TECHNICAL BULLETIN — February 2015

S16. Hoerbiger hydraulic cylinder

**Important safety related information for
Personal Restraint Systems
Models LE 25 and LE 32**

Annex 2: Inspection of the Threaded Screw Assembly

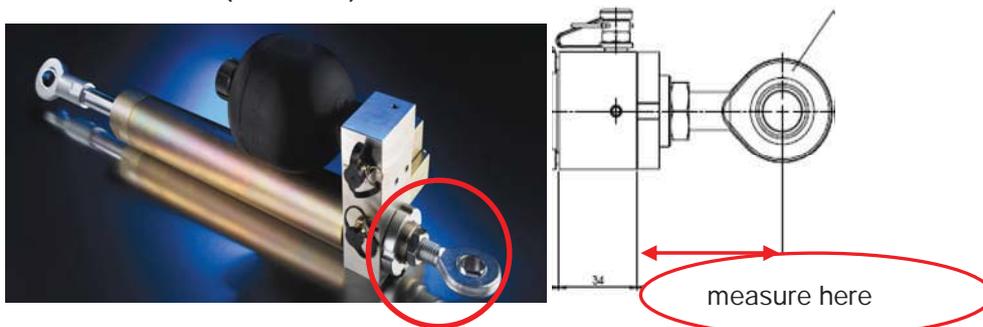
This information is important for anyone performing service on any personal restraint system using our LE assemblies and should be passed on. We have learned that some end users are sometimes unscrewing the threaded screw assembly out too far. This assembly is located on the cylinder base side and is circled in the picture below. Please note that the position of the thread is not intended as an adjustment for the spacing between two points within a personal restraint system. If this assembly is unscrewed too far there will be insufficient screw threads meeting the fitting to provide a secure connection. The result is an unsecure connection which could lead to a malfunction of the locking mechanism in the Personal Restraint System during a ride. This could cause serious injury or death. Always check that screw thread depth is correct. The diagram and photo below shows the measuring points to determine the correct screw thread depth.

The following data apply for all LE 32 versions:

For LE 32 versions the screw thread depth is correct when the rod extends no farther than distance of 64 mm (+/- 1 mm).

We strongly urge you to immediately check the measurement set out above on all Personal Restraint Systems in your possession and advise your technicians to adjust and maintain the measurements specified when installing the unit into a Personal Restraint System or during routine maintenance.

We recommend that the joint rod heads be secured at the specified dimensions and tightened with a torque wrench. The LE 25 version should be tightened to **80 Nm 10 Nm**. The LE 32 version should be tightened to **90 Nm 10 Nm**.

The correct measurement must be set and checked when installing or performing maintenance on the Cylinder Accumulator unit. In this way the required minimum screw thread depth engagement (as set out in VDI 2230) is maintained.
